**APPENDIX L**  
**TANSLEY BRIDGE CONSTRUCTABILITY REVIEW REPORT**

# TANSLEY BRIDGE CONSTRUCTABILITY REVIEW REPORT

## Dundas Street (Regional Road 5) Transportation Corridor Improvements Brant Street to Bronte Road

Class Environmental Assessment

FIGURE 2

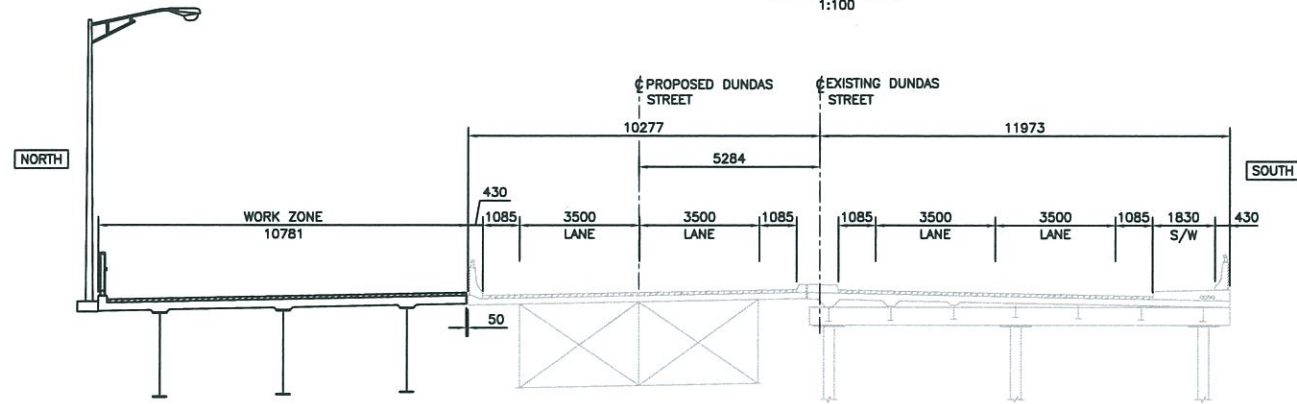
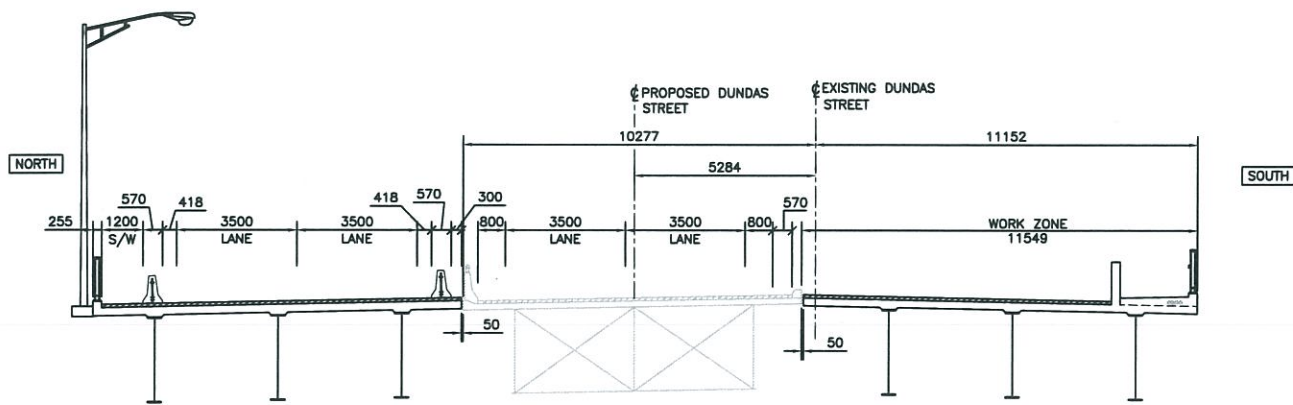
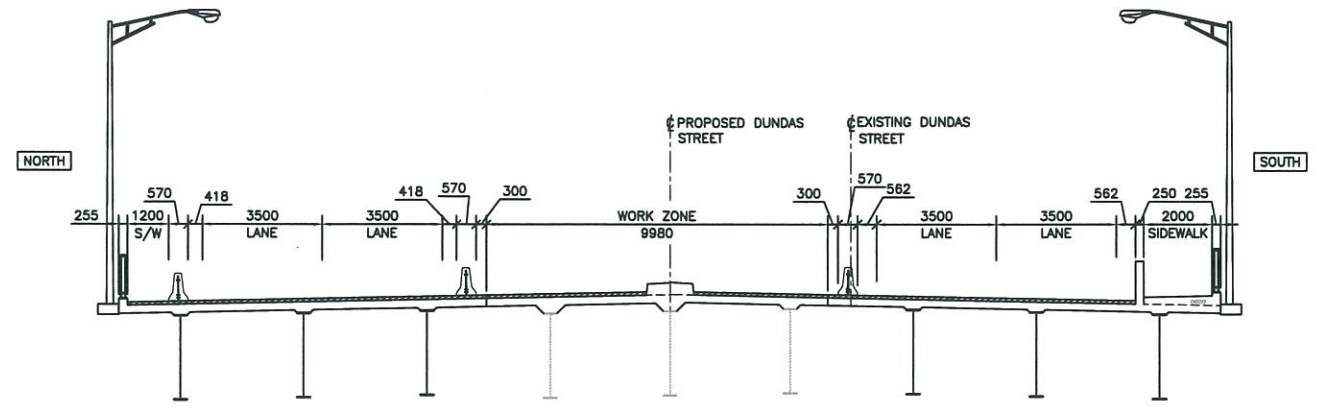
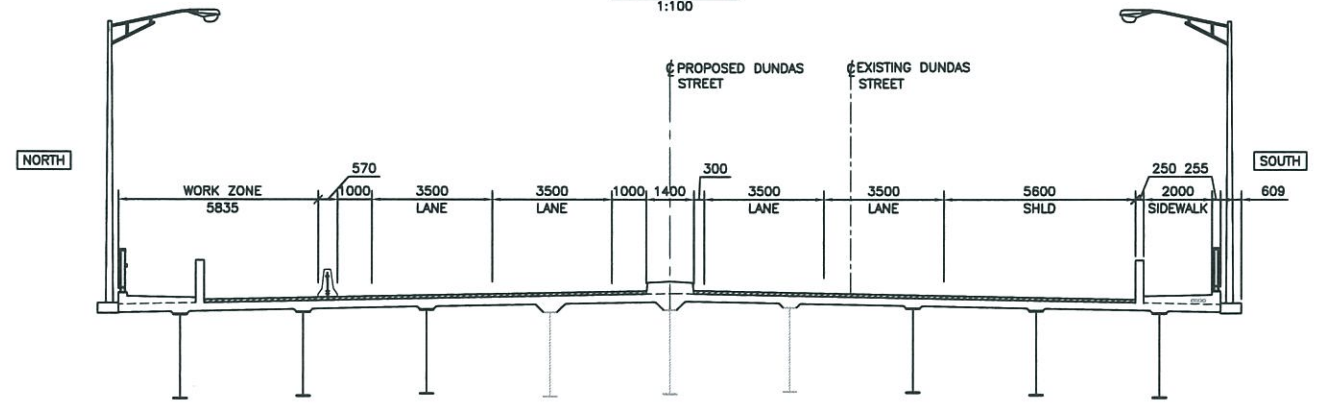
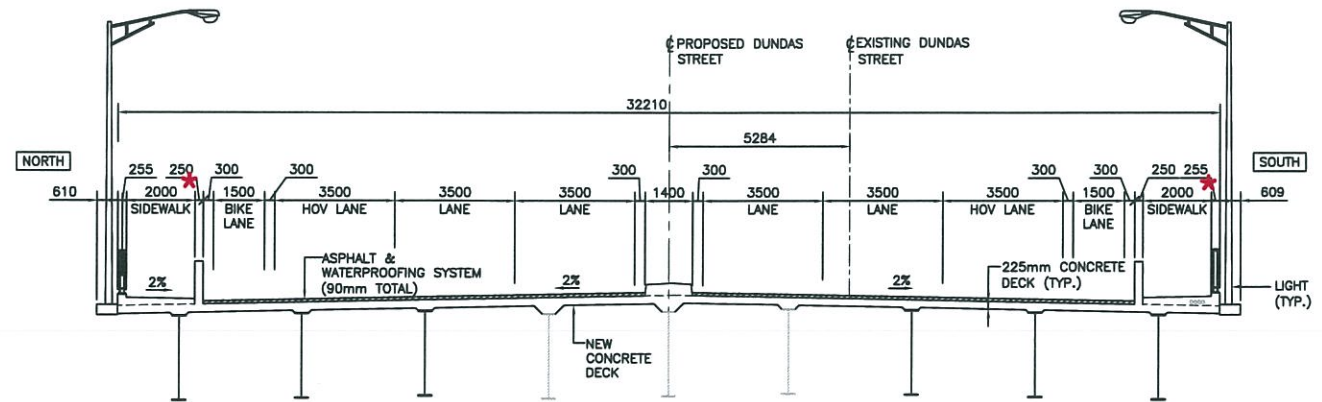
\* Sidewalk width revised to 3.0 m

**FIGURE 3**

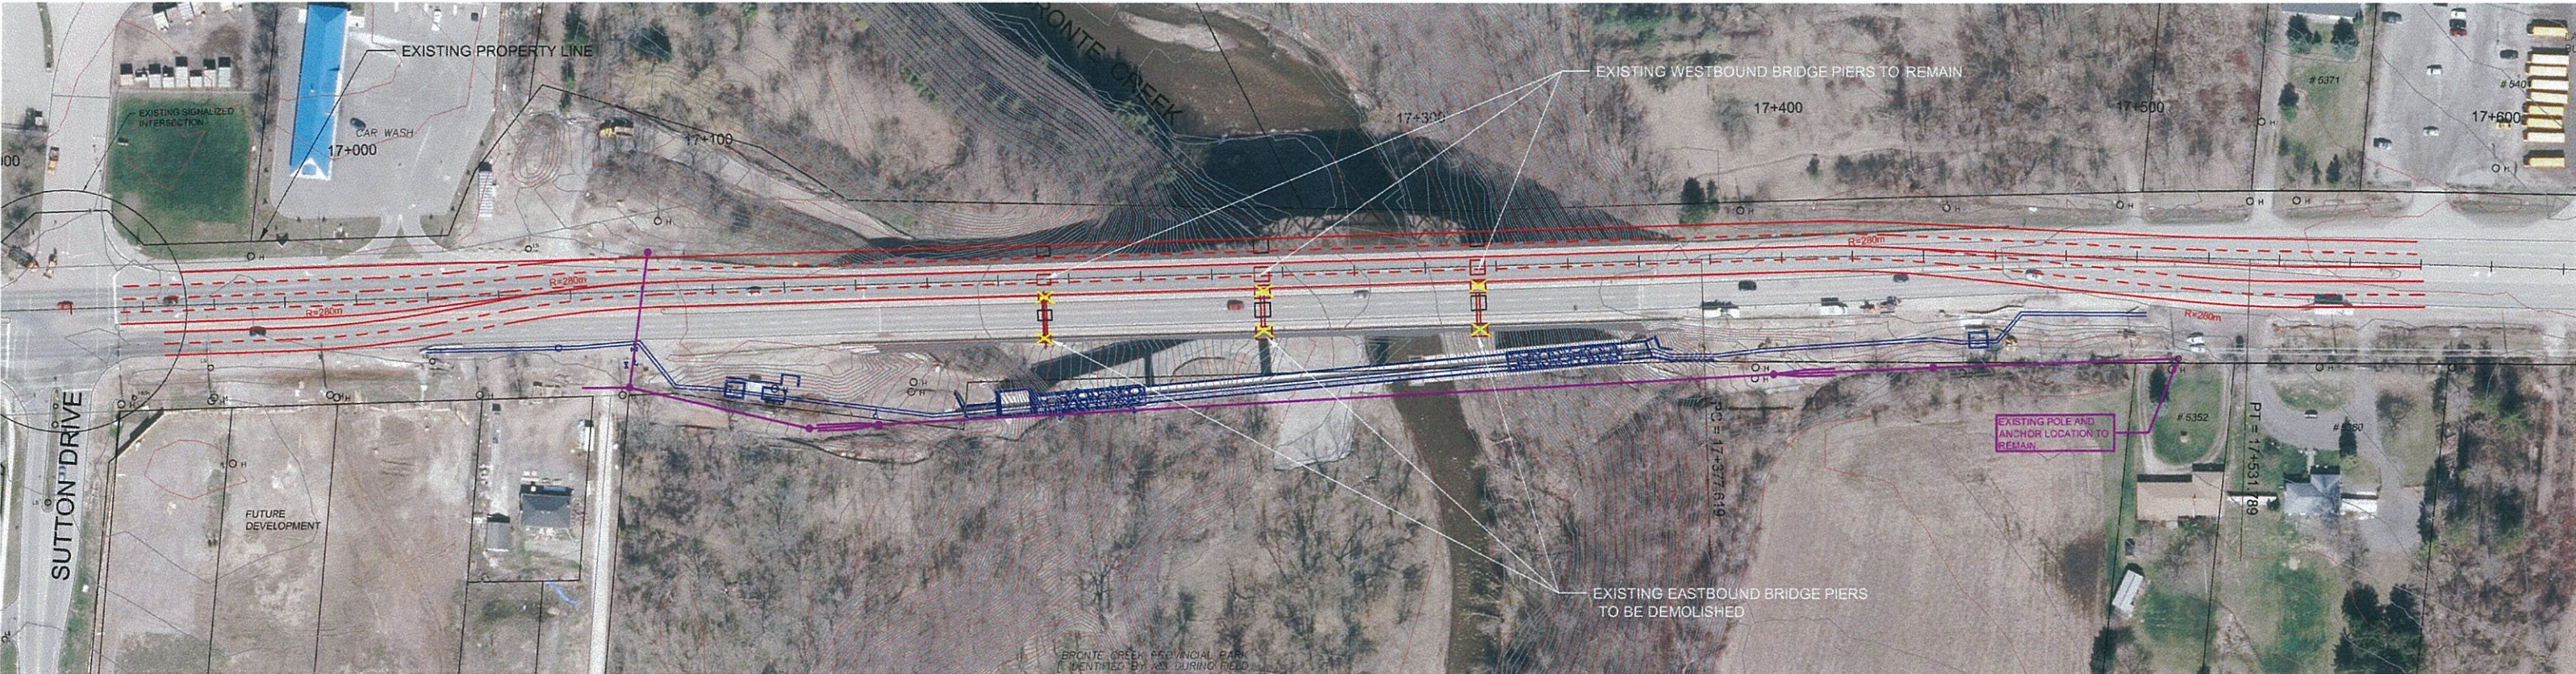
In Stage 2 of the construction, when all the traffic is detoured to the north as shown on Figure 3 included in Appendix D, the length of the west bound dedicated left-turn at Sutton Drive will be reduced to approximately half of its current length. It is recommended that traffic analysis be undertaken during detailed design so that the impacts of this reduction can be evaluated, the signal timings adjusted or other mitigation measures be enacted. Such a reduction in the left turn lane would be realized with almost all practical staging schemes. The importance of this issue will be heightened by the planned condominium and townhouse development in the south east quadrant of the Dundas Street – Sutton Drive intersection. This development will attract new additional westbound left turn movements from Dundas to Sutton Drive during the PM peak period.

Direct access to the proposed right-in/right-out at Dundas Street to the new planned condominium / townhouse development at Sutton Drive intersection may be problematic or not possible (at times) during construction. Subsequent to the Constructability Workshop, the site plan for the proposed development was updated and the right-in/right-out access is to be located at the mid-point of the property (instead of at the east end of the property initially assumed at the Constructability Workshop). The potential to maintain access during construction is more likely by having the right-in/right-out access located at the mid-point of the property. Should the access be located at the east end of the property, it would be too close to the bridge to accommodate a (large enough and) necessary laydown area at the west end of the bridge while still keeping the access to the future development open.
